Project	IEEE 802.16 Broadband Wireless Access Working Group < http://ieee802.org/16 >	
Title	Normal MAP Extension for H-ARQ	
Date Submitted	2005-01-26	
Source(s)	Yigal Eliaspur, Yuval Lomnitz, Zivan Ori	yigal.eliapsur@intel.com , yuval.lomnitz@intel.com , zivan.ori@intel.com
	Intel Corp.	geunhwi.lim@samsung.com , yongchang@samsung.com
	Geunhwi Lim, Jiho Jang, Wonil Roh, Yong Chang, Seungju Maeng	ran.yaniv@alvarion.com
	Samsung Electronics Co. Ltd.	
	Ran Yaniv Alvarion Ltd.	mhfong@nortelnetworks.com
	Mo Han Fong, Wen Tong Nortel Networks	bcihm@lge.com
	Bin-Chul Ihm LG Electronics, Inc.	mchion@ztesandiego.com
	Mary Chion, Irving Wang ZTE San Diego Inc.	scchang
	Seokheon Cho, Sungcheol Chang, Chulsik Yoon ETRI	ehosh@etri.re.kr
	Kamran Etemad Greg Schumaker Nextel Communications	jhumbe01@sprintspectrum.com
	John J. Humbert IV Sprint	radu@redlinecommunications.com
	Radu Selea, Bogdan Franovici Redline Communications

Re:	IEEE P802.16e/D5a
Abstract	The document contains suggestions for extending the Normal MAP for H-ARQ support. Additionally, certain MAC fixes are described for H-ARQ support.
Purpose	Adoption of proposed changes into P802.16e /D5a-2004
Notice	This document has been prepa

Figure XX – H-ARQ downlink allocation

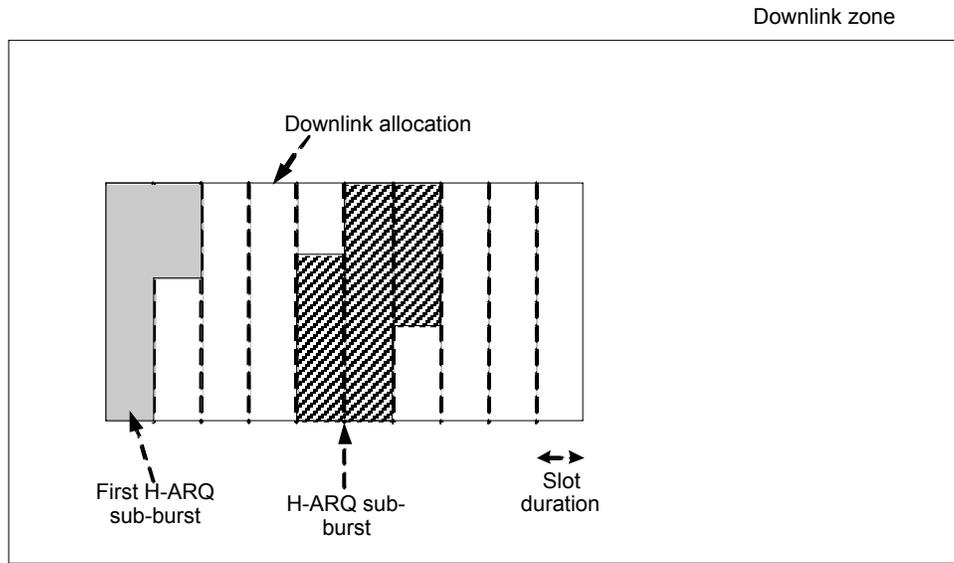
[The H-ARQ DL MAP IE defines one or more two dimensional data regions ~~allocations~~ \(a number of symbols by a number of subchannels\). ~~When the mode field indicates H-ARQ IR or Chase \(mode = 10,11\), t~~These allocations are further partitioned into bursts, termed sub-bursts, by allocating a specified number of slots to each burst. . All sub-bursts of a data region shall only support one of the H-ARQ modes. The number of slots is indicated by duration or \$N_{sch}\$ fields. The slots are allocated in a frequency-first order, starting from the slot with the smallest symbol number and smallest subchannel, and continuing to slots with increasing subchannel number. When the edge of the allocation is reached, the symbol number is increased by a slot duration, as depicted in the following diagram. Each sub-burst is separately encoded.](#)

Figure 23a Sub-MAP Burst

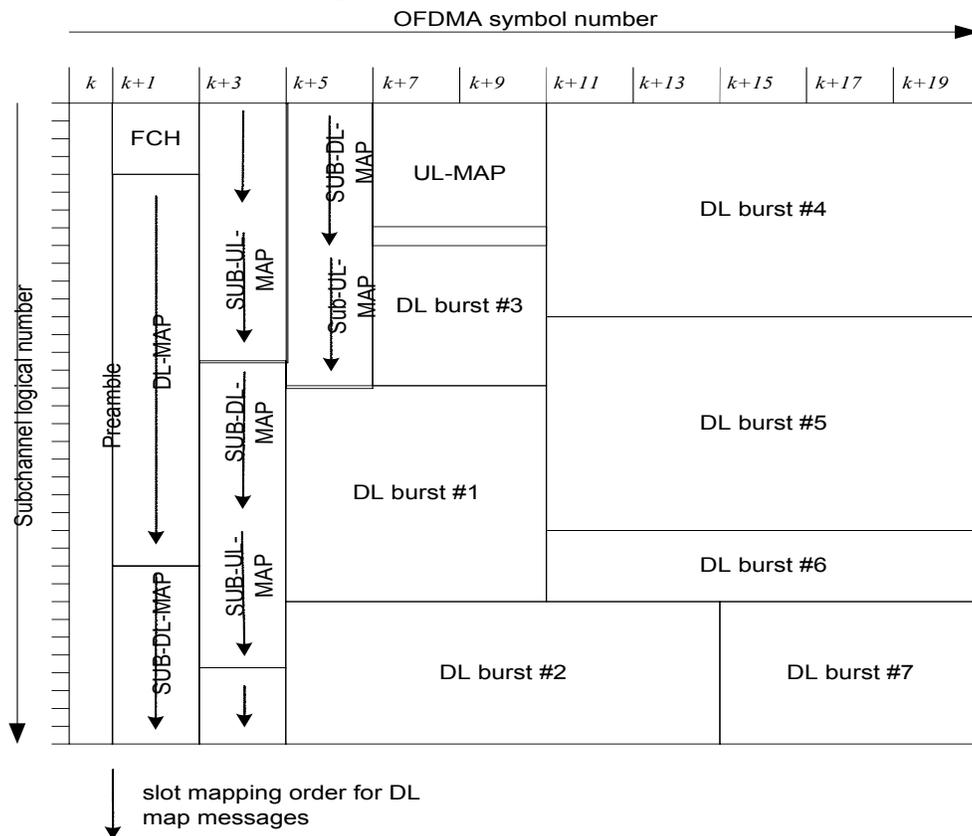
[6.3.2.3.59 Sub downlink/uplink map \(SUB-DL-UL-MAP\) message](#)

This message shall only apply to OFDMA PHY.

The SUB-DL-UL-MAP message shall appear in a compressed form, in which the generic MAC header is omitted. This is indicated by setting the two most significant bits of the first data byte in the message's PHY burst to 1 (an invalid combination for a generic MAC header).
